Model Error Resolution Document

1. Originator: Jim Houseworth/Ming Zhu	2. Date: 4/10/08	3. ERD No. MDL-NBS-HS-000006 ERD 02
4. Document Identifier: MDL-NBS-HS-000006 REV 03 AD 01	5. Document Title: UZ Flow Models and Submodels	
6. Description of and Justification for Change (Identify applicable CRs and TBVs):

Figure 6.2-1. Schematic Showing the Conceptualized Flow Processes and Effects of Capillary Barriers, Major Faults, and Perched Water Zones within a Typical Cross Section of the Unsaturated Zone Flow Model Domain in the East-West Direction

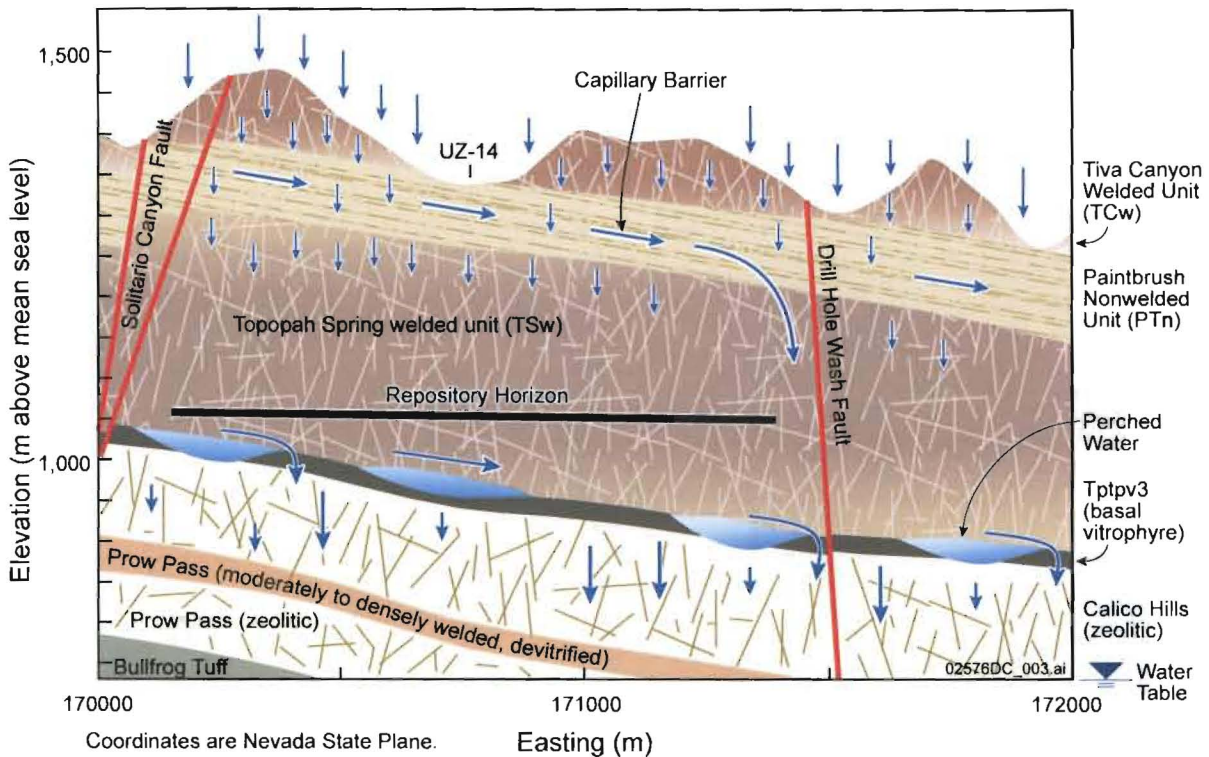
The correction to Figure 6.2-1 is editorial. The figure contains a symbol for the water table along the perched water bodies that lie above the water table.

The corrected Figure 6.2-1, where the water table symbol has been removed from the perched water area below the repository, is given below:

The only impact of this error is on DOE/RW-0573. Draft Figure 2.3.2-5 of DOE/RW-0573, Section 2.3.2 is affected because this is the same figure as shown in Figure 6.2-1 of

MDL-NBS-HS-000006 REV 03 AD 01. The change will be implemented in DOE/RW-0573. No other reports are affected by this change. This has no impact on the conclusions of MDL-NBS-HS-000006 REV 03 AD 01.
